From: Sigrun Nicodemus <sigrun.n.gadwa@gmail.com>
Sent: Wednesday, February 8, 2023 10:31 AM
To: Maureen Fitzgerald; Mark K. Branse; arlene sherman
Subject: Att. A -Carya Review App.Review, Part 2, Impacts Assmt: App. # C22-15; 141 Clark Lane.
Attachments: AttA. Rept 2. Excerpt, 2015 CTDEEP Fenger Brook Watershed Recommendations.pdf

C-22-14
109R & 131 CLARK LANE
PUBLIC HEARING
EXHIBIT # 33

Southeast Shoreline (CT2000) Summary

Fenger Brook (CT2000-30_01)

Figure 4: Impervious cover (%) for the Fenger Brook Watershed

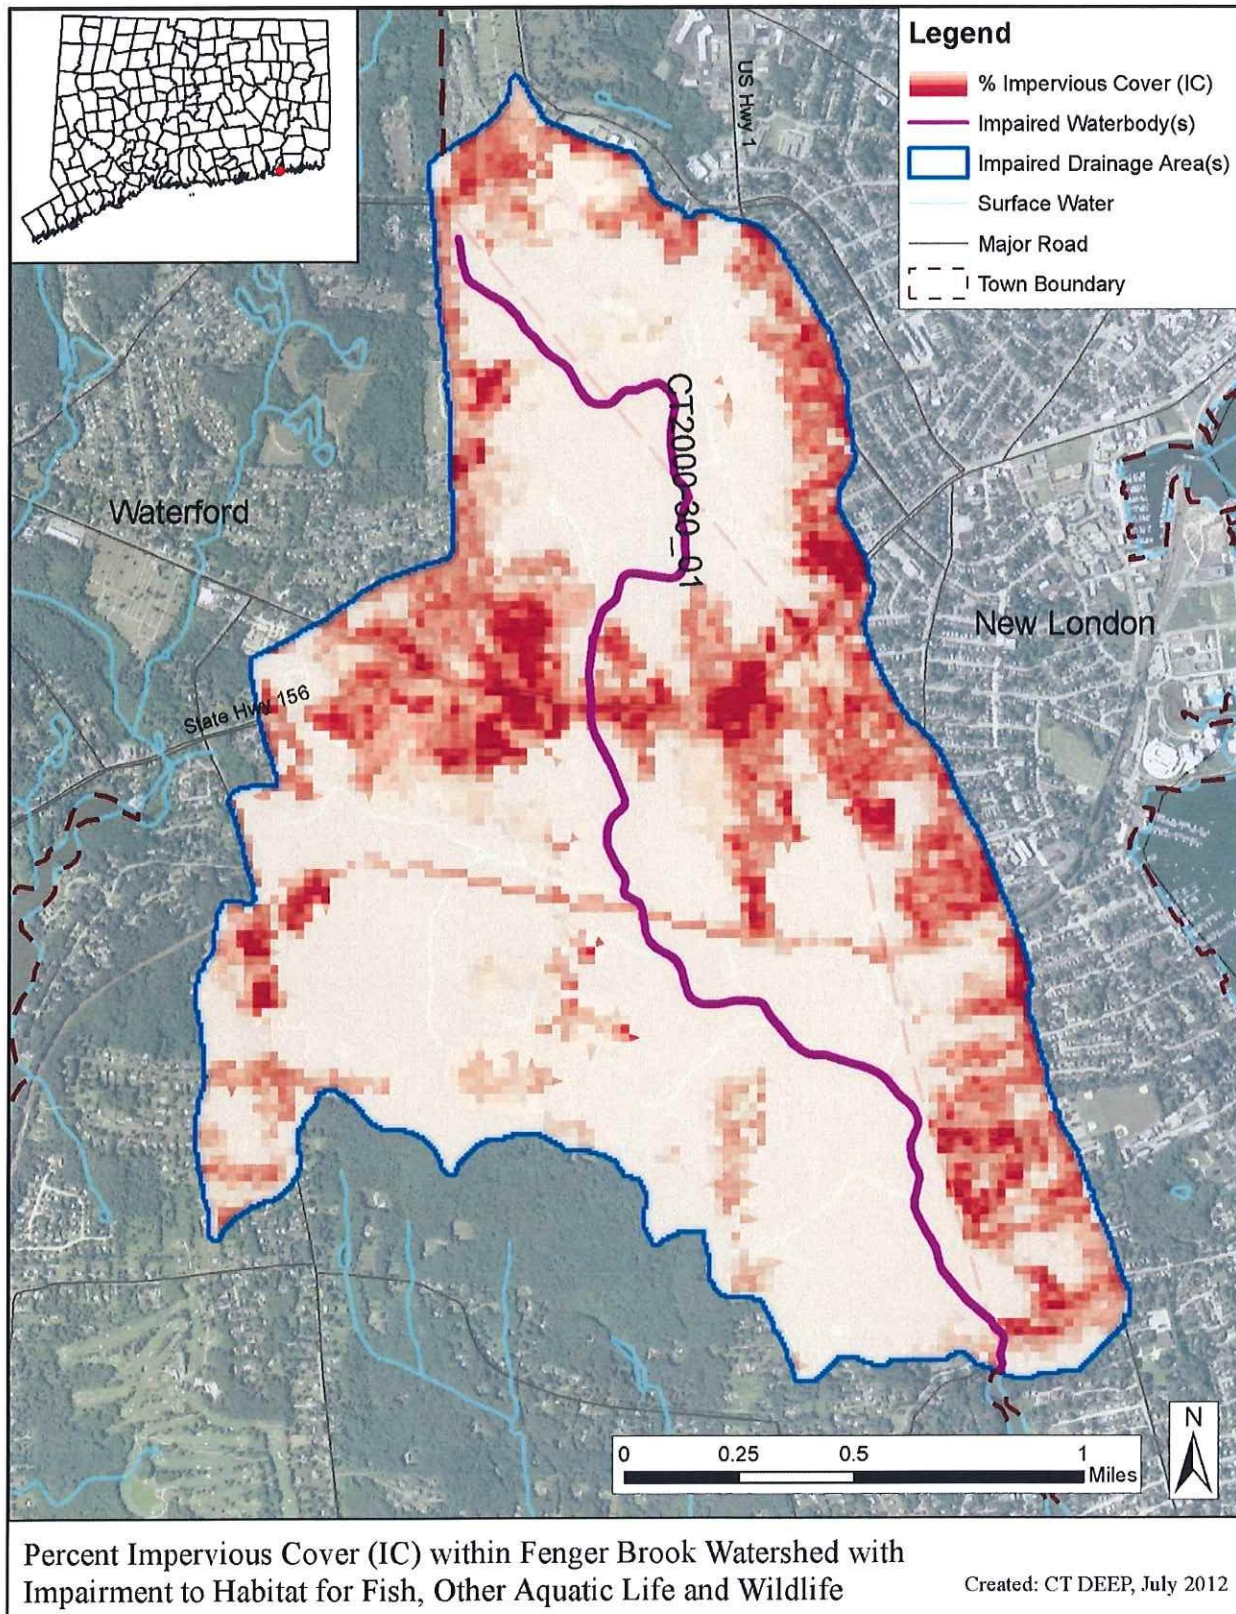
The file below is Attachment A to the Carya Report2, dated 2-7-23, which I submitted to the town electronically last night, an excerpt from the 2015 CTDEEP document, also referenced in the 1-26-23 Carya Report. The map shows the distribution of impervious surface in the Fenger Brook watershed more clearly than the photocopy attached to our first Report. The text excerpt uses disconnection of stormwater runoff with high pollutant loads from the watercourse, consistent with Carya recommendations and begins with a link to the EPA grant source for monitoring and implementing LID.

As noted previously, 38% of the Southeast Shoreline sub-regional basin is considered developed and the municipalities within the watershed are MS4 communities regulated by the MS4 program. The amount of impervious cover in the Fenger Brook watershed is 20%.

1) Reduce the effect of impervious cover in the Fenger Brook watershed through the implementation of Best Management Practices (BMPs) to control stormwater runoff.

Reducing the effect of IC in the watershed is an important step to decrease the impacts of stormwater runoff on water quality. For new development, LID principles (<http://www.ct.gov/deep/watershed>) should be utilized to retain and infiltrate stormwater runoff and/or reduce the amount of runoff from IC. In developed areas, IC should be disconnected from surface waterbodies, where practicable. Disconnection of impervious surface runoff should be pursued to the degree feasible when reconstruction of a site and/or its infrastructure occurs. For example, stormwater outfalls could be redirected to vegetated areas to encourage natural filtration before reaching nearby waterbodies.
